DMURS Report, including DMURS Statement of Consistency

Residential Development at Broomfield SHD Lands, Malahide

Broomfield SHD
Stage 1 Road Safety Audit

Stage 1 Road Safety Audit

Figure 2.1 – Example of Parking Not linked to Dwelling with Footpath

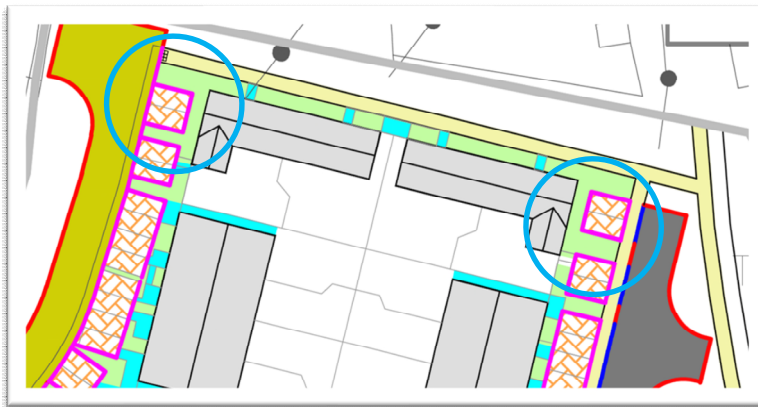
2.1 Problem: Paved Link Between Parking Spaces and Dwellings

Location: Various Locations

Some parking spaces will require vehicle occupants to walk across an unbound grass surface to get to the dwelling entrance. This could lead to slips, trips and progression issues for the mobility impaired.

A paved footpath link should be provided between all parking spaces and their respective dwelling entrances.

Response: The issue was accepted. All parking spaces were reviewed throughout the development. All parking bays now have a clearly defined pathway to the unit entrance. These pathways will be permanent surfaces to the Landscape Architects details. Please refer to Drawing number: 18-091-P002 Surfacing Layout.

2.1	Yes	Yes	All parking spaces throughout the development have been reviewed and now have a clearly defined pathway to the dwelling entrance. These pathways will be permanent surfaces to the Landscape Architects Details.	<i>Noted with thanks.</i>

Figure 2.2 – Reversing into Desire Line

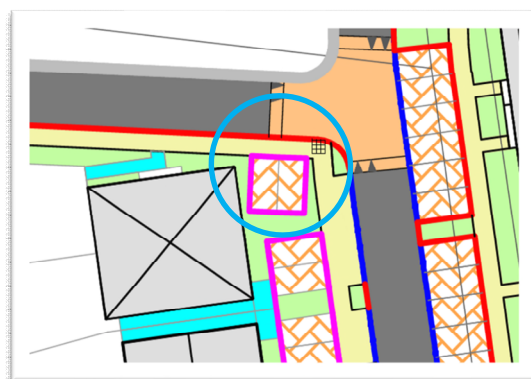
2.2 Problem: Reversing into Junction

Location: Dual Parking Spaces Near Junction – Road Layout Sheet 2 of 3

Drivers are likely to reverse into the junction, across a formal pedestrian crossing. This could lead to an increased risk of conflicts between vulnerable road users and vehicles.

The parking spaces should be re-orientated to mitigate the risk described.

Response: The issue was accepted. These areas where this issued occurred were redesigned so that the private parking bays were either reorientated or relocated and now will no longer have a reversing movement into the junctions.

2.2	Yes	Yes	These areas where this issued occurred were redesigned so that the parking bays were either reorientated or relocated and now will no longer have a reversing movement into the junctions. Extract of road surfacing layout: 	<i>Noted with thanks.</i>

Figure 2.3 – Absence of Pedestrian Facilities

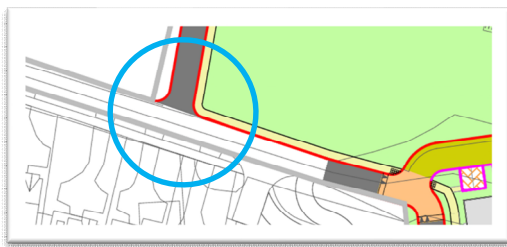
2.4 Problem: Providing for Pedestrians Crossing

Location: T-Junction – Road Layout Sheet 1 of 3

Failure to slow vehicles and guide pedestrians across the junction safely could lead to an increased risk of collisions between general traffic and pedestrians.

Provisions to slow vehicles and guide pedestrians across the junction safely should be made in a consistent manner with the other junctions within the development.

Response: A raised table and pedestrian crossing have been introduced at this location. The pedestrian crossing will connect to the footpath of the adjacent development which has been granted planning permission by Reg ref: Fingal County Council: F13A/0459 & ABP: PI06F.243863. Final decision to grant date: 10/03/2015 by ABP.

2.4	Yes	Yes	<p>A raised table and pedestrian crossing, identified by blister tactile paving, has been incorporated to the design at this location. Extract from surfacing layout:</p> 	<i>Noted with thanks.</i>

Figure 2.4 – Crossing Desire Lines

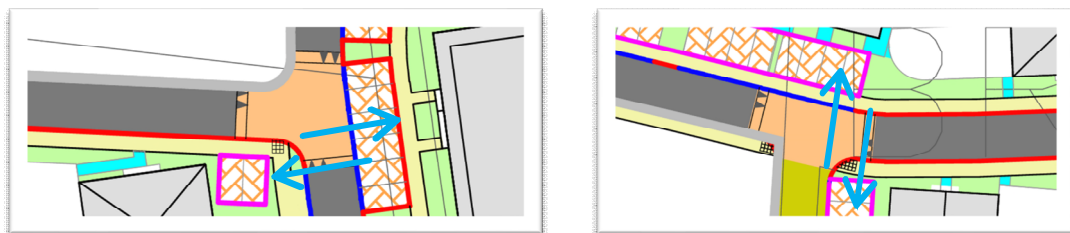
2.5 Problem: Providing for Pedestrians Crossing

Location: T-Junctions – Road Layout Sheet 2 of 3

Failure to provide for the crossing desire lines could lead to an increased risk of collisions between general traffic and pedestrians.

The crossing desire lines (highlighted) should be formally provided for at the junctions.

Response: The issue was accepted. Pedestrian crossings have been incorporated at the specified locations, with the parking bays having been relocated to accommodate the pedestrian crossing. A grass verge has been provided between the relocated parking bays and the pedestrian crossing so as to enhance motorist visibility of pedestrians intending to utilise the crossings. Due to alterations to the layout, the solution to this issue has been incorporated to further locations throughout the site in order to enhance pedestrian connectivity and safety.

2.5	Yes	Yes	<p>Pedestrian crossings have been incorporated at the specified locations, with parking bays having been relocated to accommodate the crossings. A grass verge has been provided between the relocated bays and the crossings so as to enhance motorist visibility of pedestrians approaching the crossings. Due to alterations to the layout, the solution has been incorporated to further locations throughout the site in order to enhance</p>	<i>Noted with thanks.</i>

Figure 2.5 – Low Radii Curves

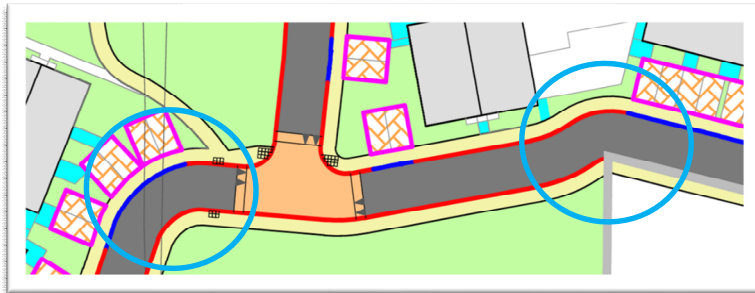
2.6 Problem: Low Radii Curves Leading to Opposition Conflicts

Location: Alignment of Internal Road – Road Layout Sheet 2 of 3

The relatively low radius horizontal curves will require quite abrupt changes in direction for drivers negotiating this section of road. This could result in opposing vehicles striking each other.

A vehicle swept path analysis should be undertaken to establish the appropriateness of the geometry, with the radii increased if required.

Response: The issue was accepted. The road alignment geometry has been revised and swept path analysis undertaken shows no issues for cars navigating the area.

2.6	Yes	Yes	<p>A swept path analysis was undertaken at this location and confirmed the issue. The roads geometric alignment at this location was reviewed and redesigned with larger radii curves introduced. A swept path analysis was again undertaken for a large family car/van size vehicle which now shows no lane crossing following on from the redesign. Extract from swept path analysis:</p> 	<i>Noted with thanks.</i>

Figure 2.6 – Narrow Footpath

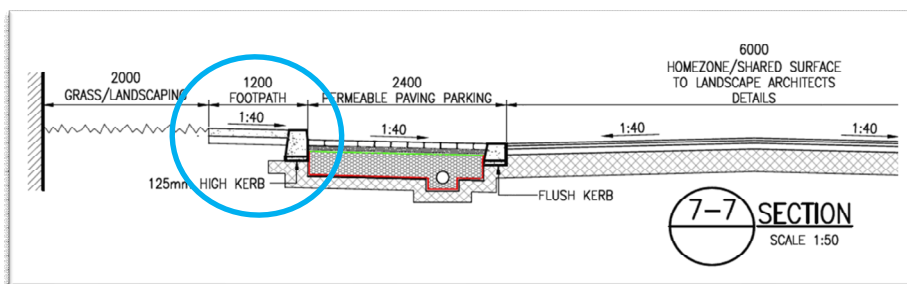
2.7 Problem: Narrow Footpath Encroached by Car Door Swing

Location: Section 7-7 of Road Cross Sections Drawing

The narrow footpath will be encroached upon by car doors opening, leading to door strikes and to pedestrians being forced to step into unbound grassed areas.

The footpath should be widened to mitigate the risk described.

Response: The issue was accepted. In line with a request from Fingal County Council, all footpaths throughout the development are now at least 2m wide. This 2m width is sufficient to allow pedestrians to manoeuvre around open car doors without having to use unbound surfaces, at locations where parallel parking bays are adjacent to the footpath.

2.7	Yes	Yes	<p>In line with the findings of the Audit & FCC requests, footpaths throughout the development have now been increased in width and are at least 2m wide at all locations. This 2m width is sufficient to allow pedestrians to manoeuvre around open car doors without having to use unbound surfaces, at locations where</p>	<i>Noted with thanks.</i>

Figure 2.7 – Crossing Desire Lines

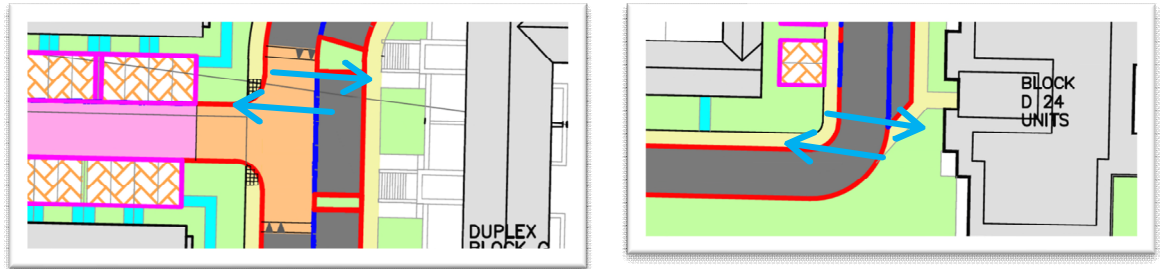
2.8 Problem: Providing for Pedestrians Crossing

Location: T-Junction and Apartment Block D – Road Layout Sheet 3 of 3

Failure to provide for the crossing desire lines could lead to an increased risk of collisions between general traffic and pedestrians.

The crossing desire lines (highlighted) should be formally provided for at the junctions.

Response: The issue was accepted. The locations highlighted have undergone a total redesign for an unrelated reason. Provision of formal pedestrian crossings along desire lines has been incorporated to the redesign.

Figure 2.8 – Crossing Desire Lines

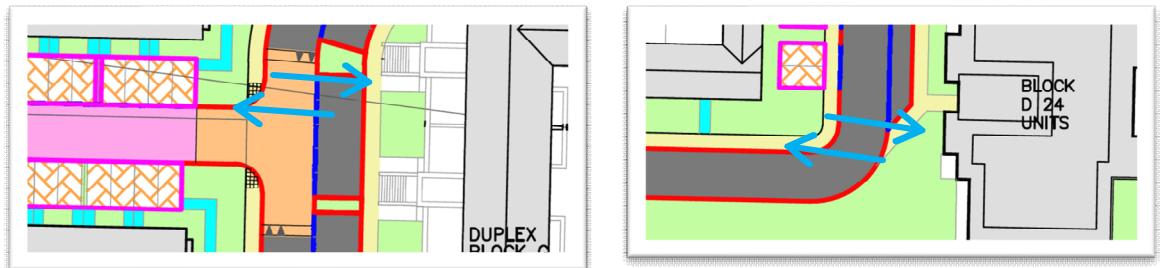
2.9 Problem: Providing for Pedestrian Crossing

Location: T-Junction – Road Layout Sheet 3 of 3

Failure to provide for the crossing desire lines could lead to an increased risk of collisions between general traffic and pedestrians.

The crossing desire lines (highlighted) should be formally provided for at the junctions.

Problem Reference (Section 2)	Designer Response Section			Audit Team Response Section
	Problem Accepted (yes / no)	Recommended Measure Accepted (yes / no)	Alternative Measures or Comments	Alternative Measures Accepted (yes / no)
			parallel parking bays are adjacent to the footpath.	
2.8	Yes	Yes	<p>The locations highlighted have undergone a total redesign for an unrelated reason. The redesign has incorporated the recommendation for the provision of pedestrian crossings along desire lines. Sample extract from road surfacing layout:</p> 	<i>Noted with thanks.</i>
